To: INCITS T10 Committee
From: Susan Gray, Quantum
Date: January 5, 2004
Document Number: T10/04-014r1
Subject: ADT SCSI Application Diagrams

2 Discussion

Section 8 of ADT describes the mapping between SCSI protocol services defined in SAM-2 and the services provided by ADT. In previous group discussions, it was mentioned that it would make the section more understandable if diagrams were provided. This proposal is to add diagrams for clarification.

Figure X SCSI Command with no data phase

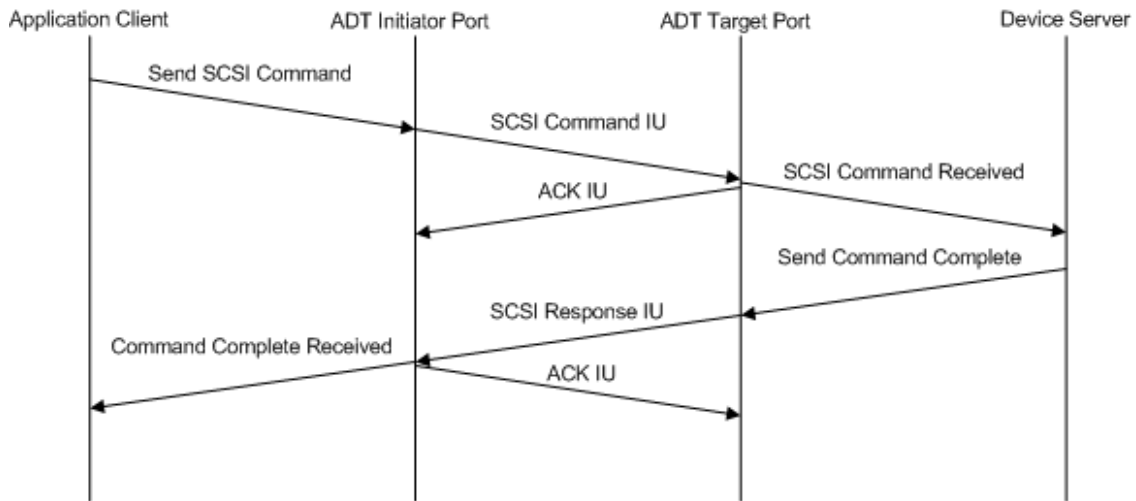
A.2 SCSI command with no data phase

Figure x shows how SCSI transport protocol services may be used to process a SCSI command that has no data phase.

Figure x + 1 SCSI Command with Data In

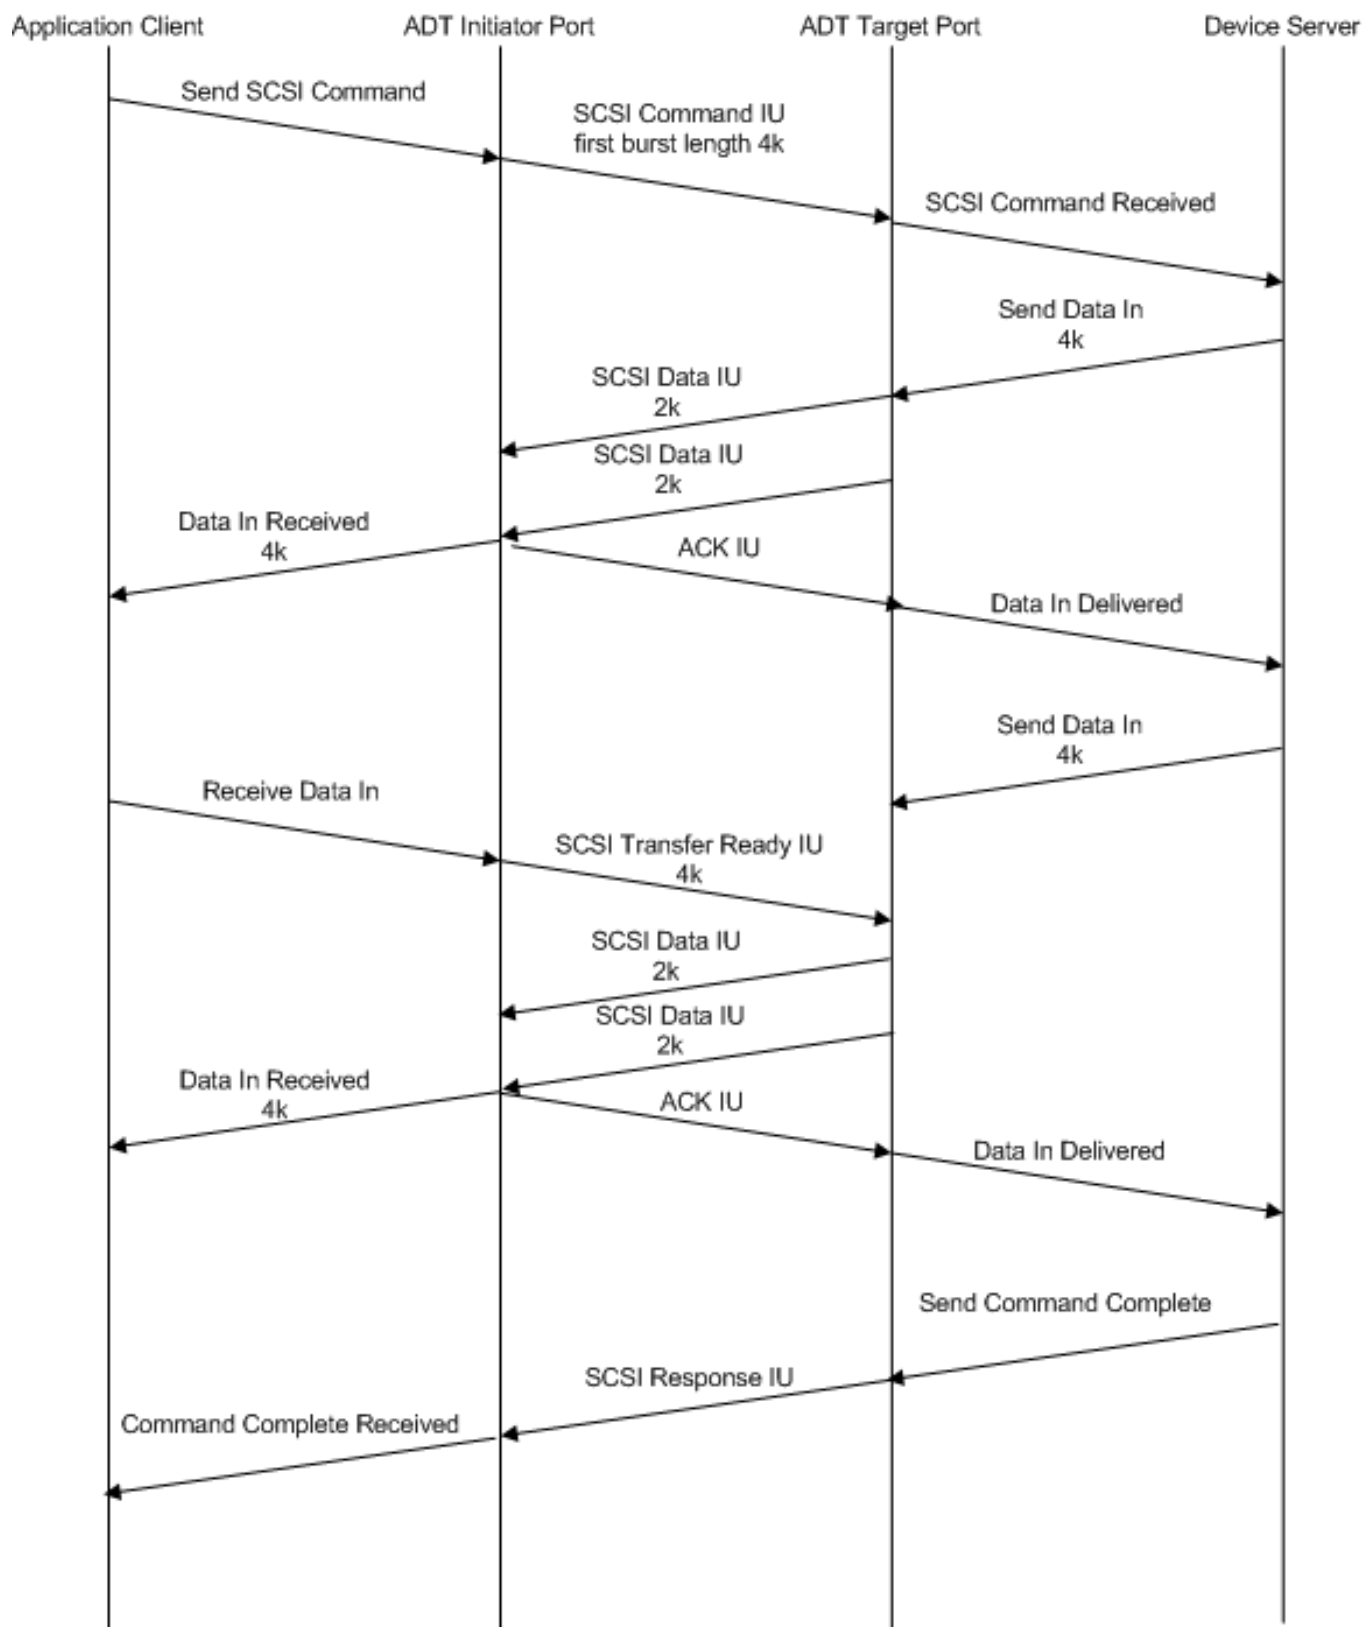
Figure x + 1 shows how SCSI transport protocol services may be used to process a SCSI command with a data-in phase. All IUs transferred between the ADT ports are acknowledged using ACK IUs. Most of the ACK IUs are not shown in this figure in an effort to make it more readable. The ACK IUs that are shown are those that have a direct impact on the communication between the ADT target port and device server.

There are many possible variations of the order and number of protocol service calls and SCSI Data IUs. This is one example of how a SCSI command with data-in may be accomplished.

This example shows a SCSI command that has an overall data-in length of 8k, but the data-in buffer size in the Send SCSI Command request is 4k. The SCSI Command IU has a FIRST BURST LENGTH field value of 4k which has the effect of a SCSI Transfer Ready IU with a BUFFER OFFSET field of zero and a BURST LENGTH field of 4k (see 7.1.2).

Once the device server receives the SCSI Command Received indication, it requests 4k of data to be transferred to the application client. The ADT target port uses multiple SCSI Data IUs to transfer the data to the ADT initiator port. Once it has received the FIRST BURST LENGTH number of bytes it sends a Data-In Received confirmation to the application client. Once the last SCSI Data IU has been acknowledged, the ADT target port notifies the device server using the Data-In Delivered confirmation.

The device server may send more data at any time using the Send Data-In request, but the ADT target port waits until it has received a SCSI Transfer Ready IU (see 7.1.5) before transmitting a SCSI Data IU. When the application client issues a Receive Data-In request, the ADT initiator port transmits a SCSI Transfer Ready IU. The ADT target port responds by transmitting data using one or more SCSI Data IUs until BURST LENGTH bytes (see 7.1.5) of data have been sent.

When the device server has completed sending all the data-in for the command, it uses the Send Command Complete protocol service to request the ADT target port transmit a SCSI Response IU. Upon receiving the SCSI Response IU, the ADT initiator port notifies the application client using the Command Complete protocol service.

Figure x + 2 SCSI Command with Data Out

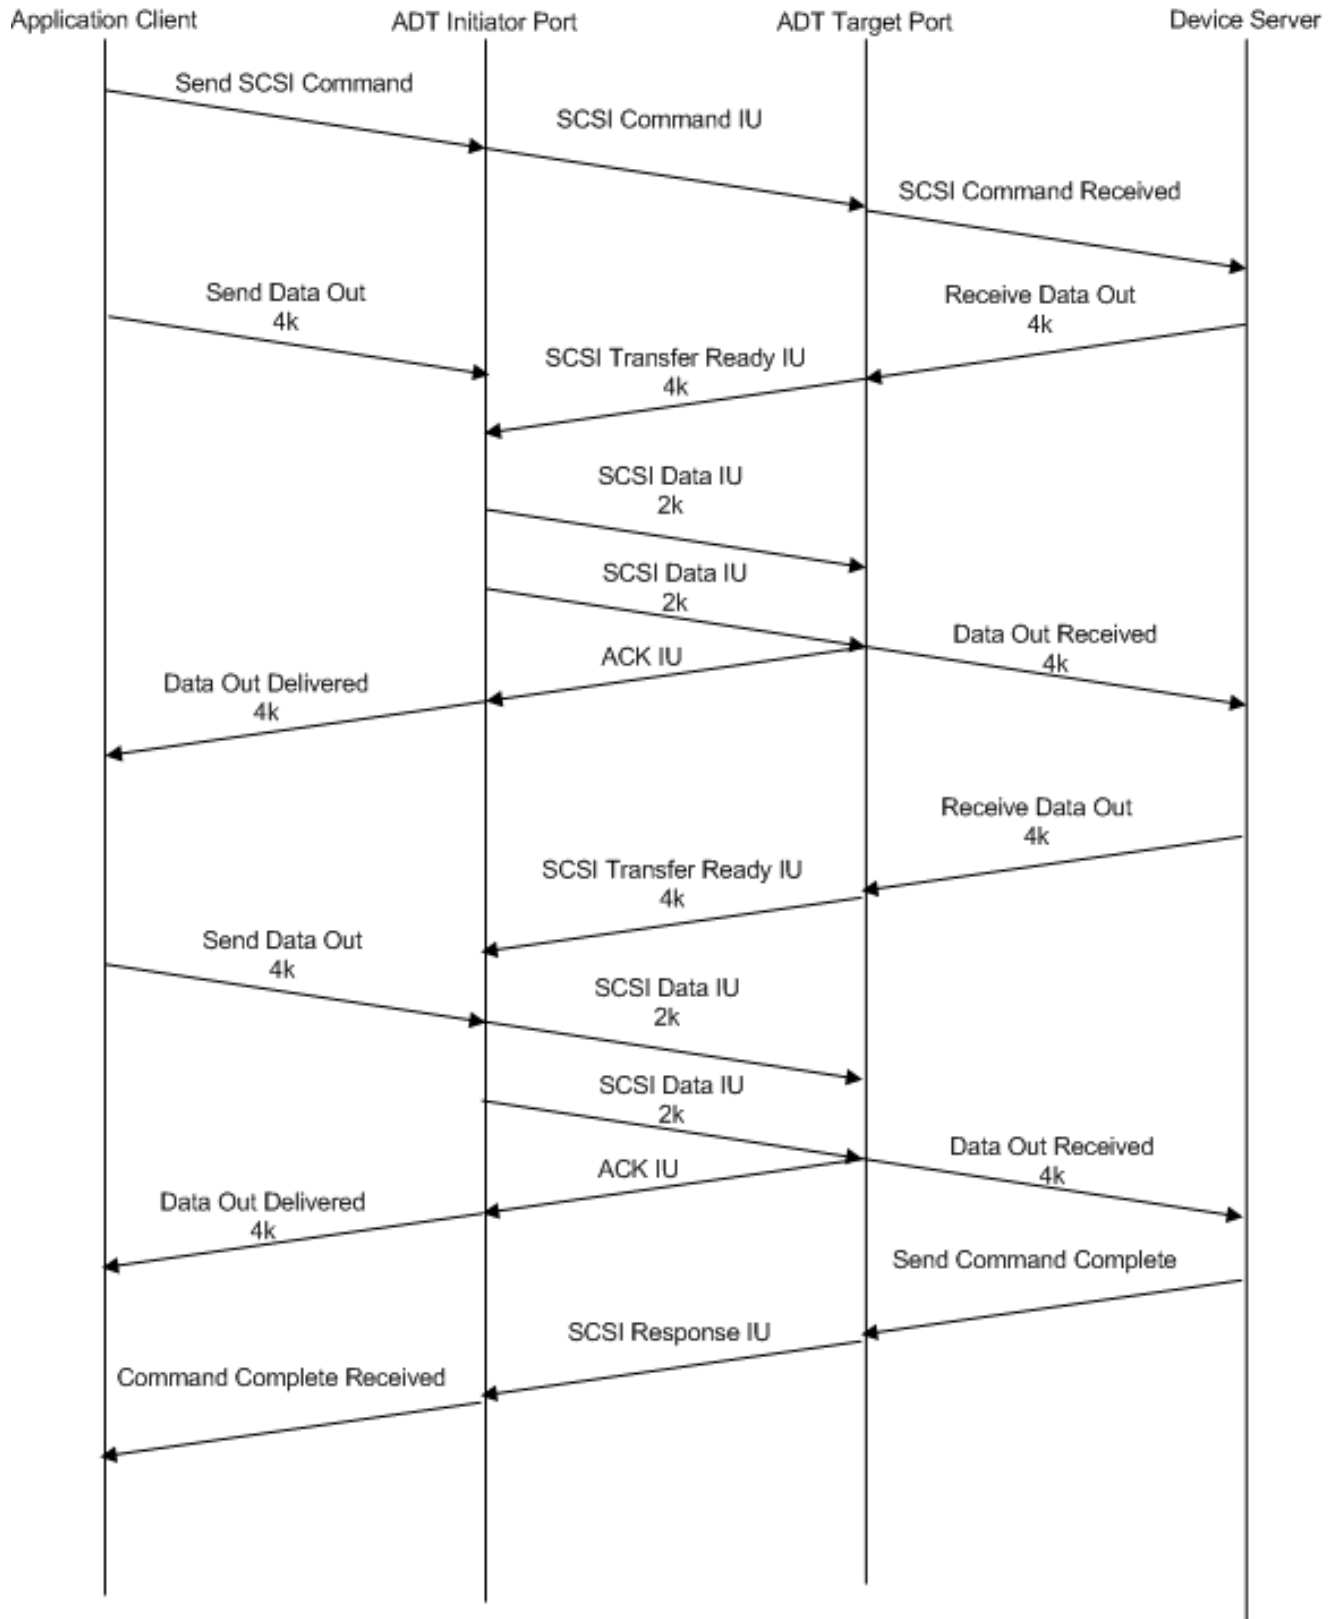
Figure x + 2 shows how SCSI transport protocol services may be used to process a SCSI command with a data-out phase. All IUs transferred between the ADT ports are acknowledged. Most of the ACK IUs are not shown in this figure in an effort to make it more readable. The ACK IUs that are shown are those that have a direct impact on the communication between the ADT initiator port and application client.

There are many possible variations of the order and number of protocol service calls and SCSI Data IUs. This is one example of how a SCSI command with data-out may be accomplished.

This example shows a SCSI command that has an overall data-out length of 8k, but the data-out buffer size in the Send SCSI Command request is 0k. Instead it uses the Send Data-Out protocol service to request the data to be transferred.

The application client requests 4k of data to be transferred to the device server, using the Send Data-Out protocol service. The ADT initiator port waits to transfer the data until it has received a SCSI Transfer Ready IU (see 7.1.5). The device server uses the Receive Data-Out protocol service to request a SCSI Transfer Ready IU be transmitted. The ADT initiator port uses multiple SCSI Data IUs to transmit the data. Once the last SCSI Data IU has been acknowledged, the ADT initiator port notifies the application client using the Data-Out Delivered confirmation.

Once the ADT target port has received the number of bytes requested it notifies the device server using the Data-Out Received confirmation. This process repeats a second time to transfer the remaining 4k of data.

When the device server has received all of the data for the command, it uses the Send Command Complete protocol service to request the ADT target port transmit a SCSI Response IU. Upon receiving the SCSI Response IU, the ADT initiator port notifies the application client using the Command Complete protocol service.
